Amendments to the Drawings:

Attachment: Annotated Sheets Showing Changes

REMARKS/ARGUMENTS

Fig 14A

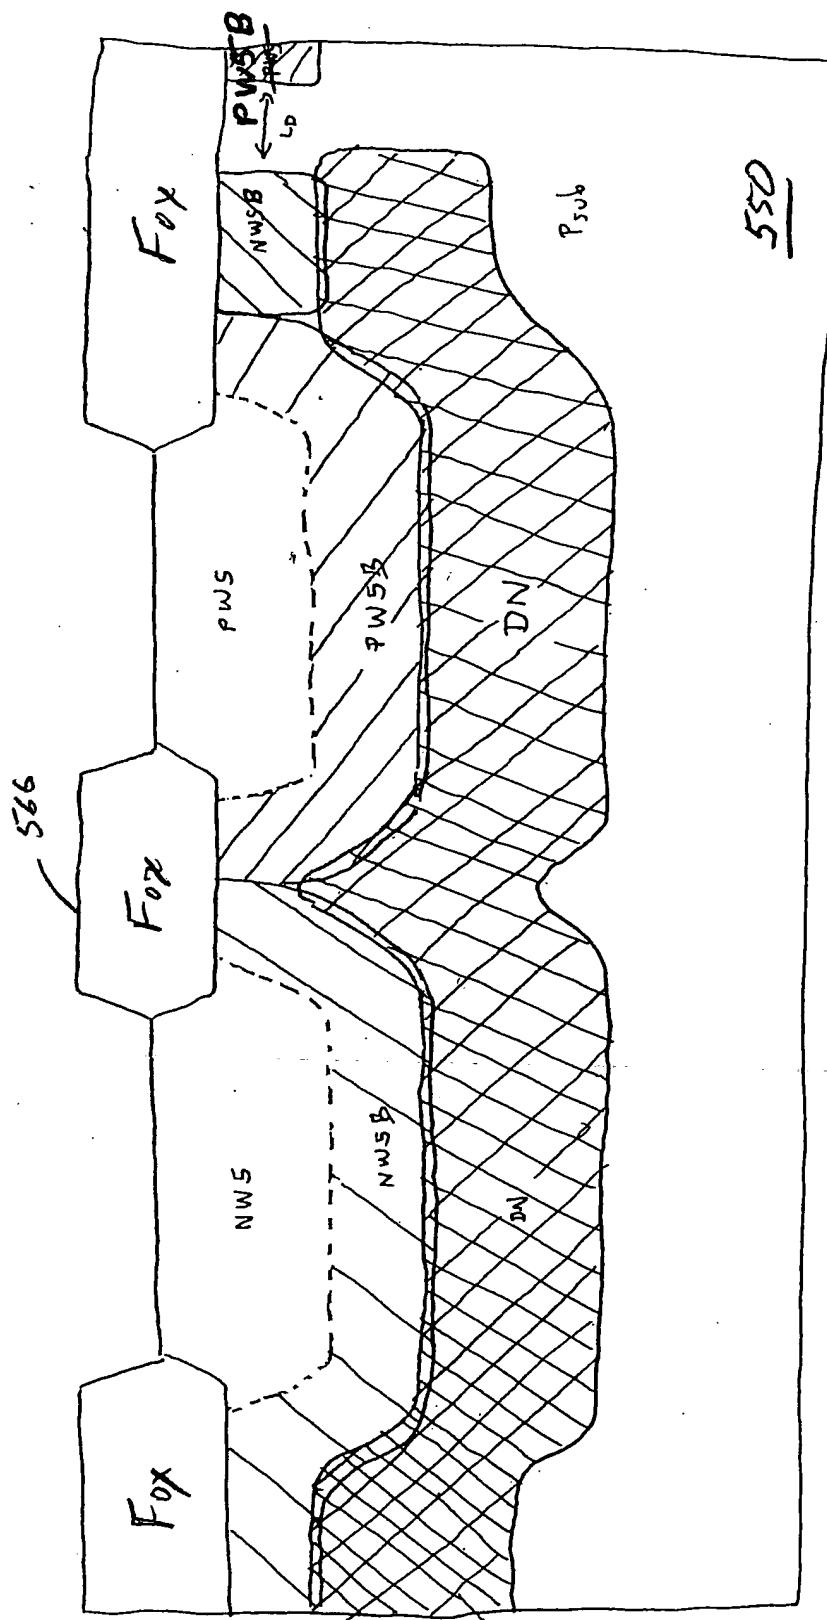
In Figs. 14A-14E, 14H-14P, 15A, 16A, 16B, 16D and 16F, in a number of instances the reference numeral PW5 has been changed to PW5B, the reference numeral NW5 has been changed to NW5B, the reference numeral PW12 has been changed to PW12B, and the reference numeral NW12 has been changed to NW12B, as shown on the enclosed Annotated Sheets. These changes are clearly supported, for example, at page 36, lines 14-17, of the substitute specification filed February 18, 2004, where it is indicated that the suffix "B" is used to denote an implanted layer of dopant as opposed to a "well" of dopant. In any event, these changes are merely changes in labeling and as such do not constitute new matter.

Fig. 18B

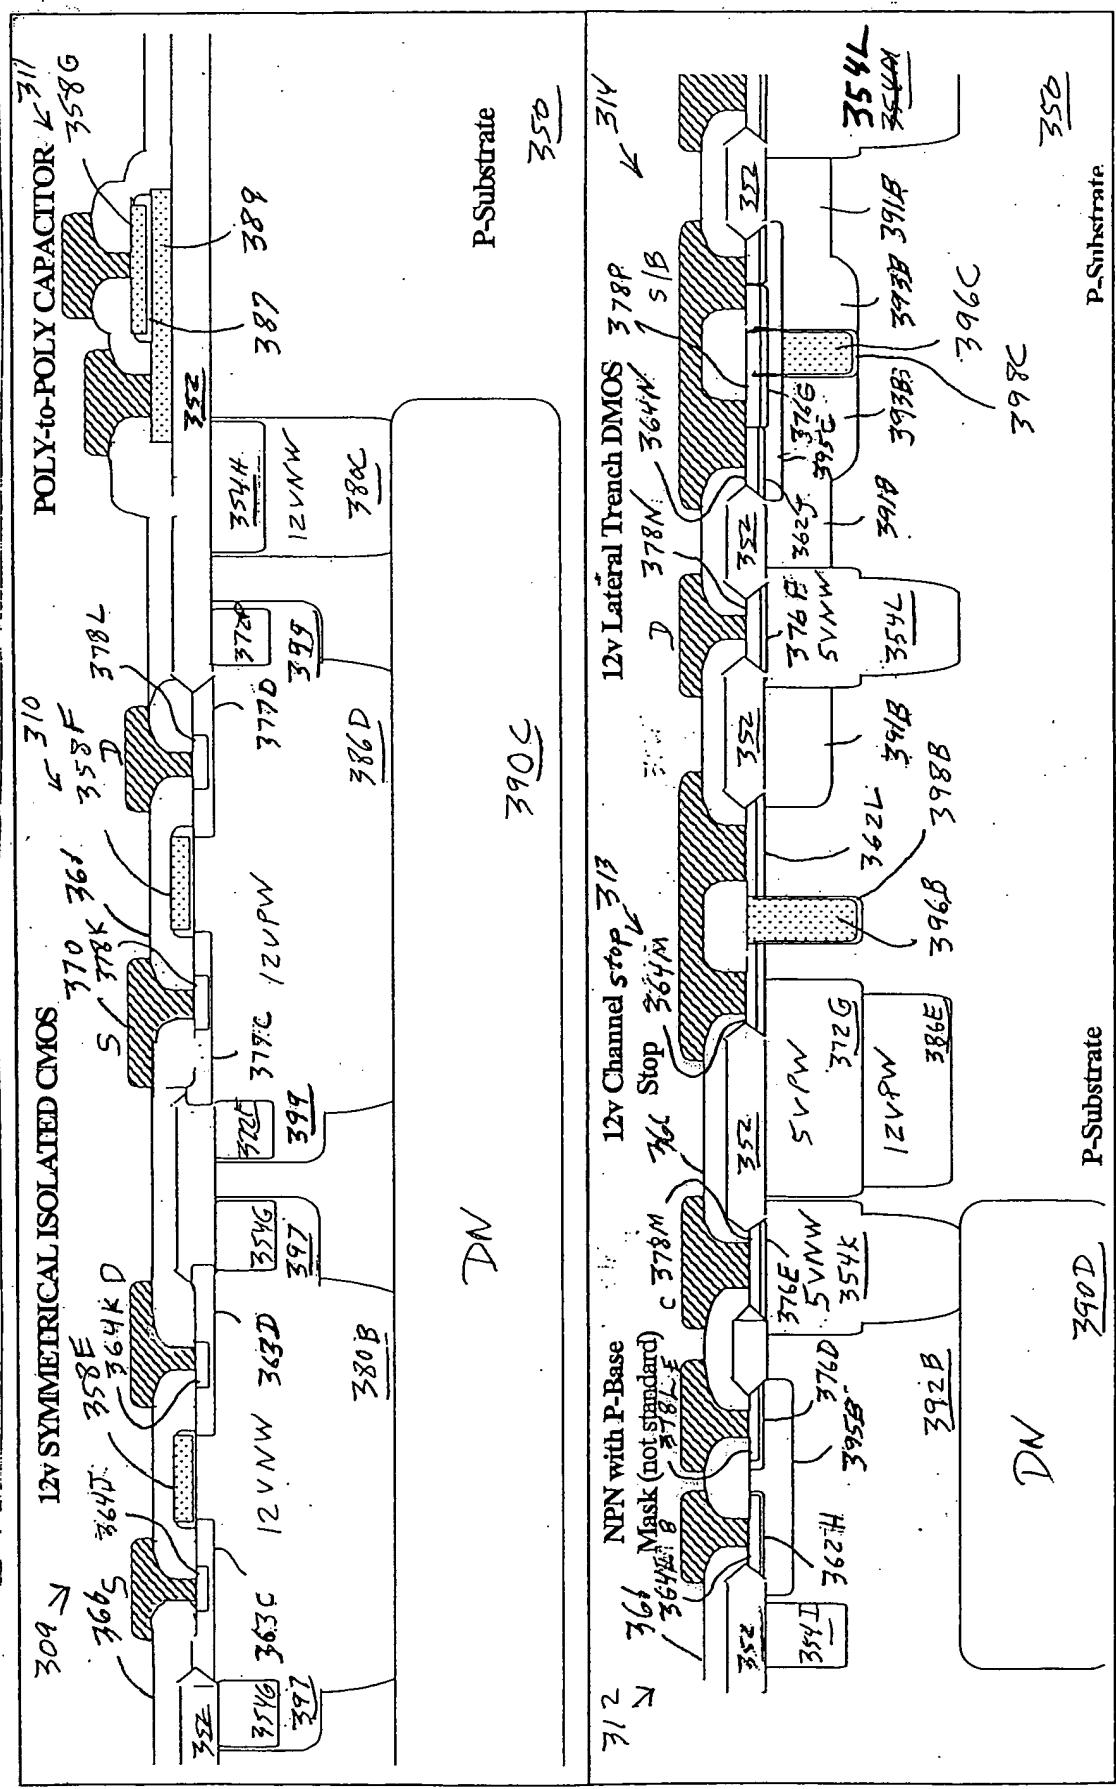
To make the drawings more legible, Figs. 18A and 18B have each been split into four drawings, designated Figs. 18A-1 to 18A-4 and Figs. 18B-1 to 18B-4, respectively. The subject matter in Figs. 18A-1 to 18A-4 and 18B-1 to 18B-3 is unchanged. In Fig. 18B-4, the reference numeral 354M has been replaced by the numeral 354L. The numeral 354M was an error. There is no such reference numeral in the application as filed.

Fig. 18C

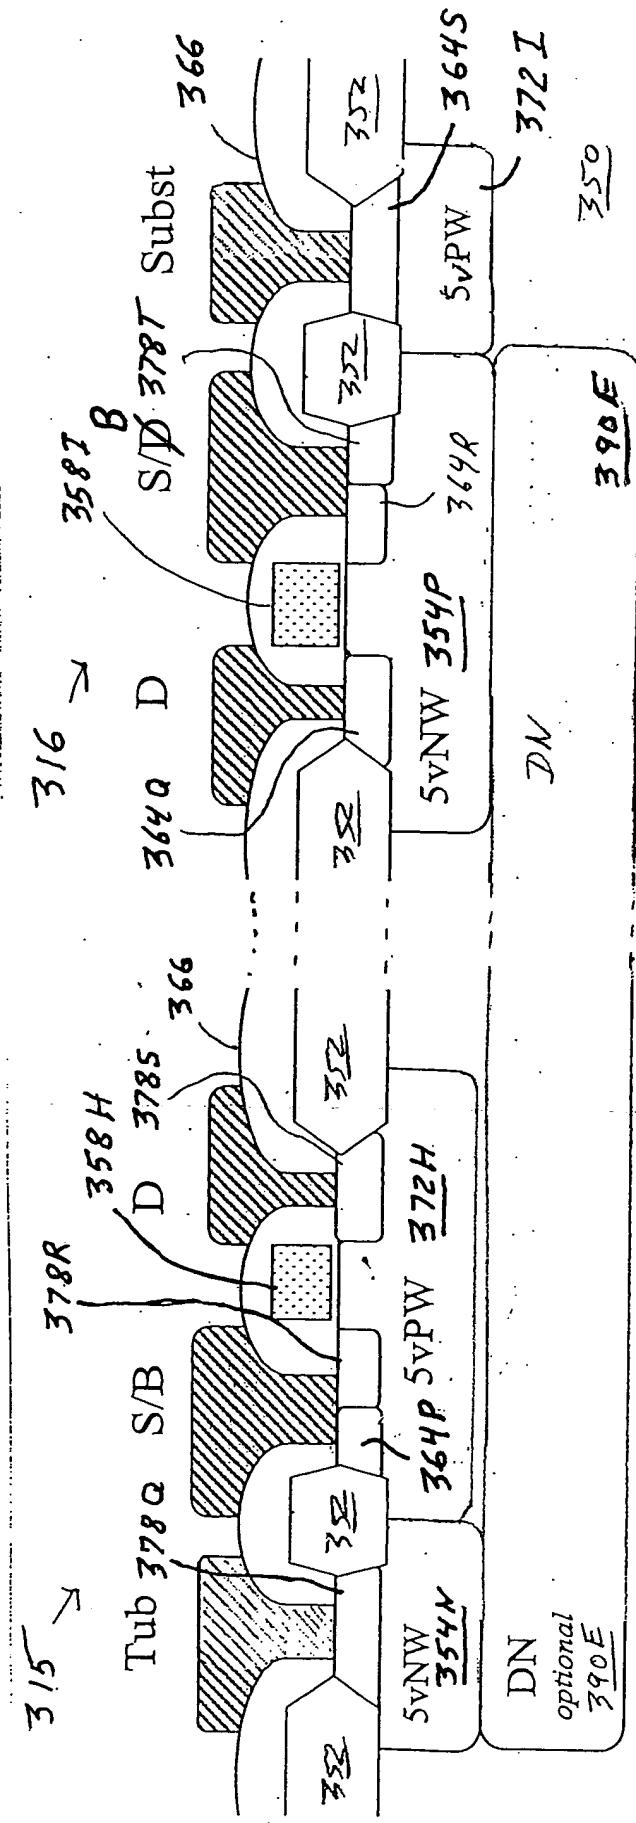
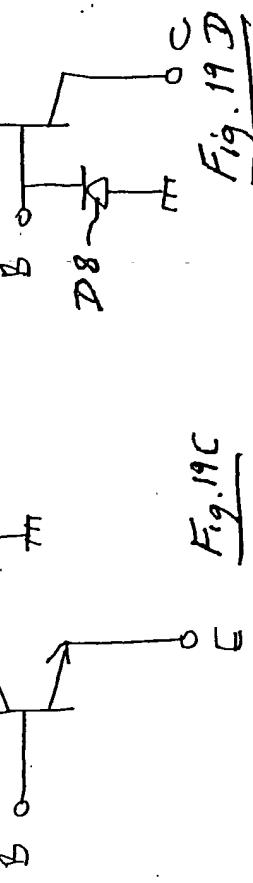
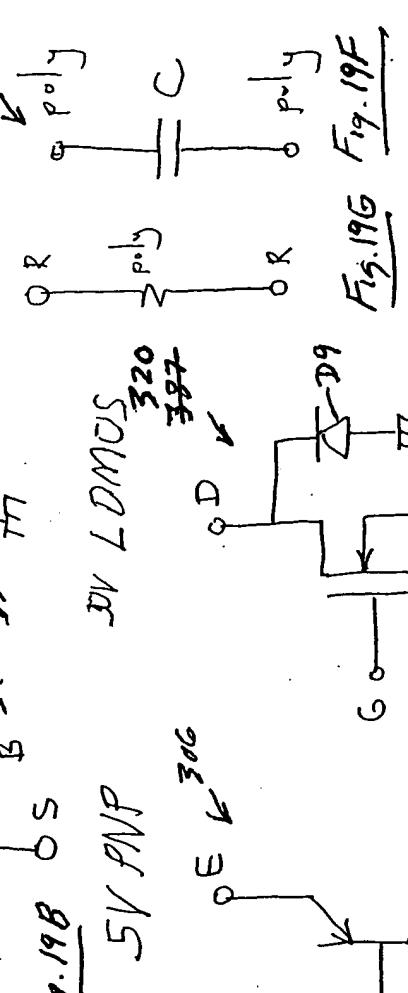
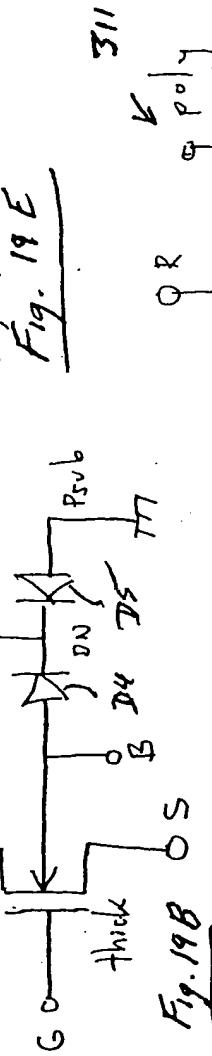
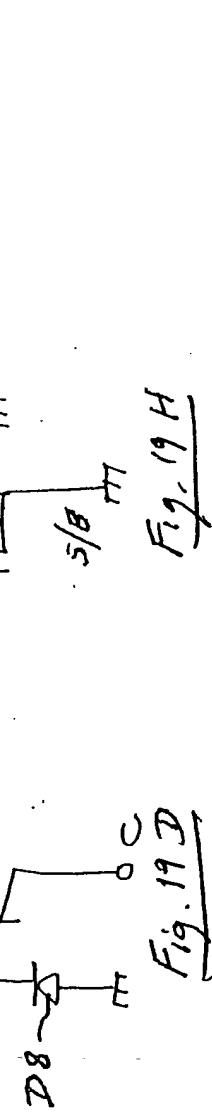
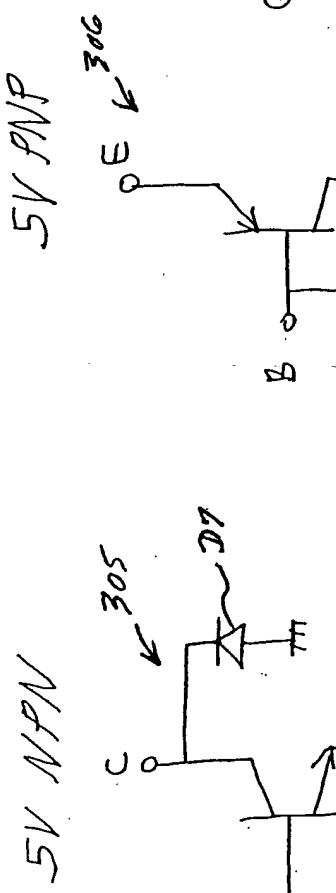
In Fig. 18C, the reference numeral 364P, which is referred to at page 66, line 4, of the substitute specification, has been added, and the designation of the source-body contact has been corrected from "S/D" to "S/B".

Interlayer Dielectric
Fig 33D

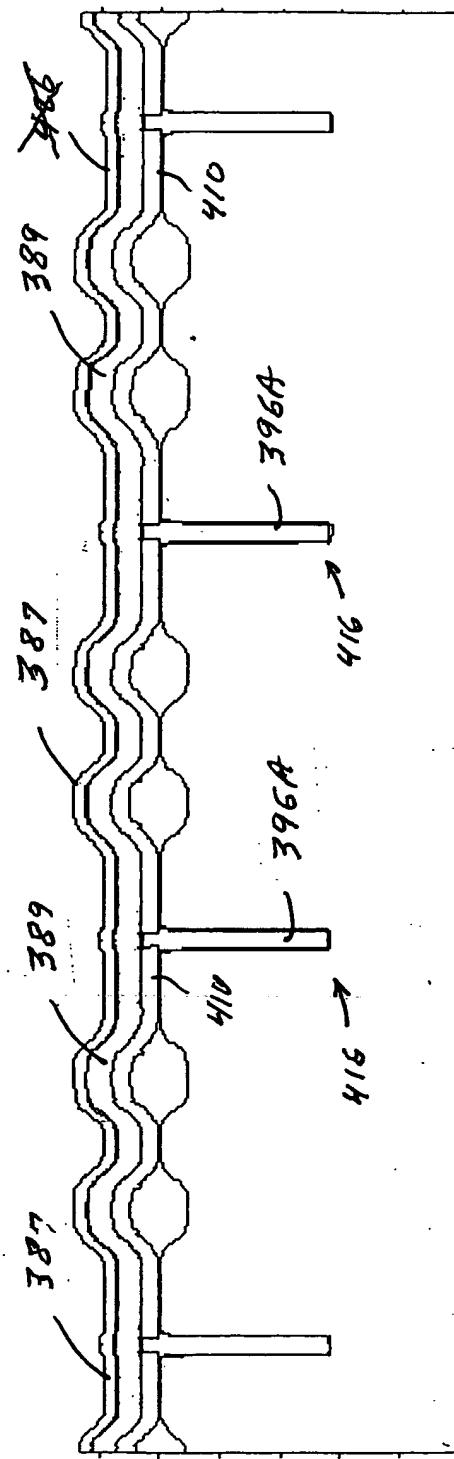
In Fig. 33D, the reference numeral 486 has been deleted. It is not referenced in the specification.

Interlayer Dielectric Deposition and Etch
Fig. 64B

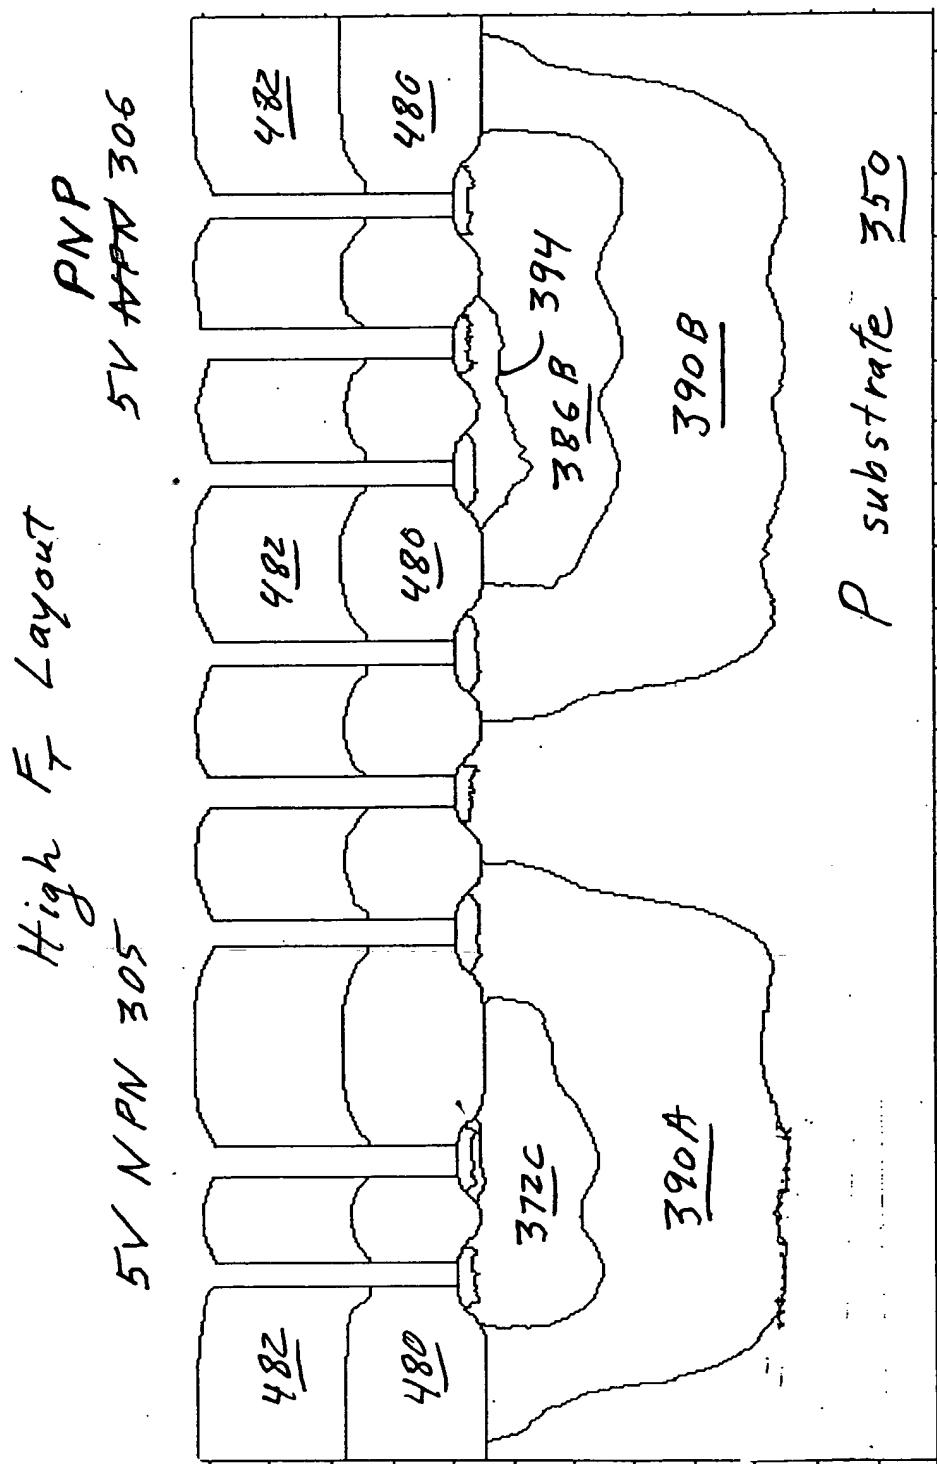
In Fig. 64B, the description of the 5 volt transistor 306 as been corrected to "PNP."

Fig. 18H

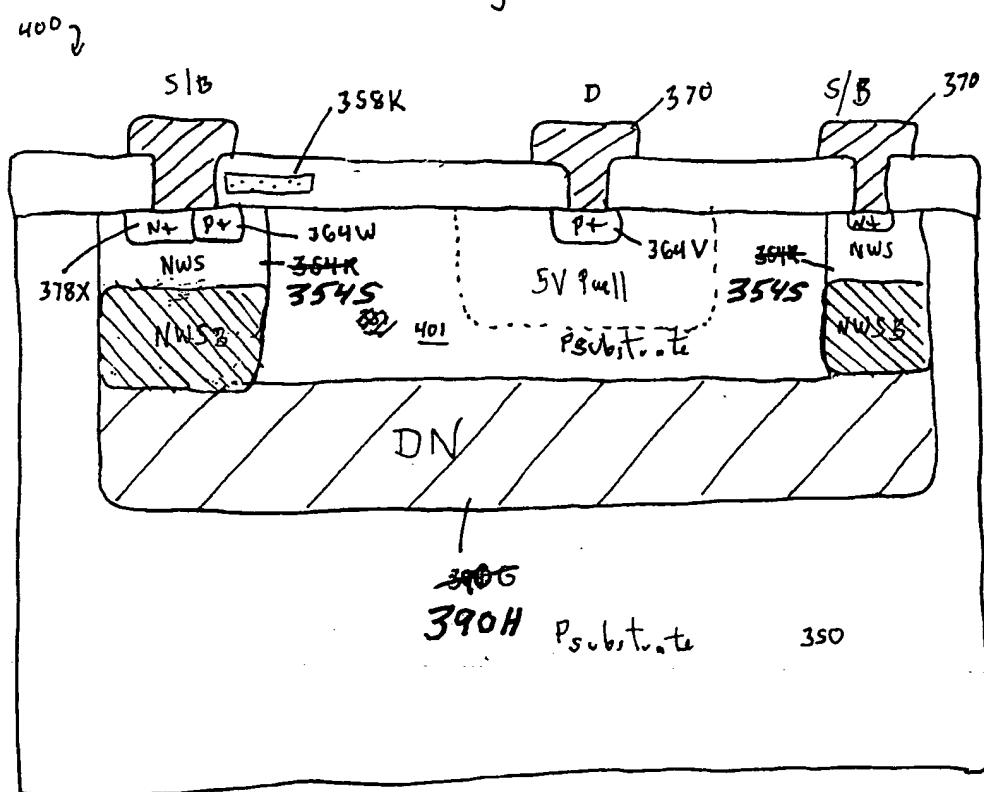
In Fig. 18H, the reference numeral applicable to the well NW5 has been changed from 354R to 354S to eliminate the conflict with the similarly numbered element in Fig.

18G; and the reference numeral applicable to the deep N layer has been changed from 390G to 390H to eliminate the conflict with the similarly numbered element in Fig. 35A.
